**Addendum #2 To  
Request for Proposal  
For Chilled Water Loop from Chemistry to LSB 2014: Project 006-245418**

**Dated February 5, 2014**

**A diagram of the installation is included with this addendum.**

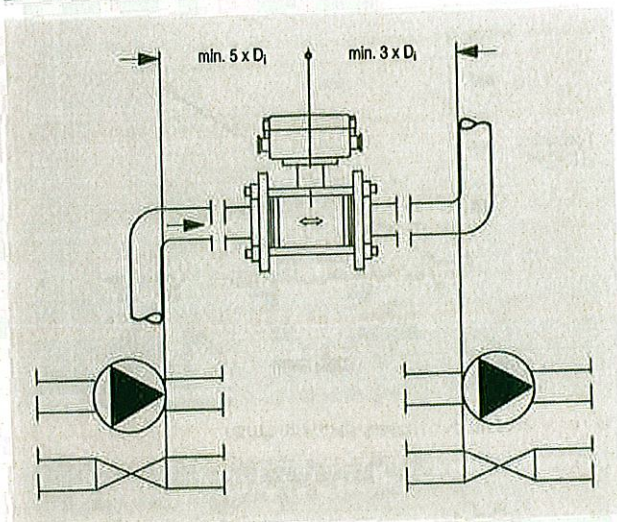
1. Install a 6 inch flow meter (supplied by Siemens) in a straight length of chilled water supply piping. The meter should be installed with a minimum of 5 pipe diameters before the meter and at least 3 pipe diameters after the meter. See attached sketch for more details.
2. A ½" NPT threaded valve will need to be installed in the CHW supply and return piping AFTER the tap in the Life Science mechanical room. These will be for the supply and return water temperature sensors that will be furnished by Siemens. A total of 2 (two) is required.
3. A ½" NPT threaded valve with shut-off valve will need to be installed 30 degrees off the bottom of the pipe for the differential pressure transmitters that Siemens will be furnishing. A total of 2 (two) will be required. They are to be installed by the mechanical contractor.
4. Coordinate with Siemens prior to actual installation of these devices.
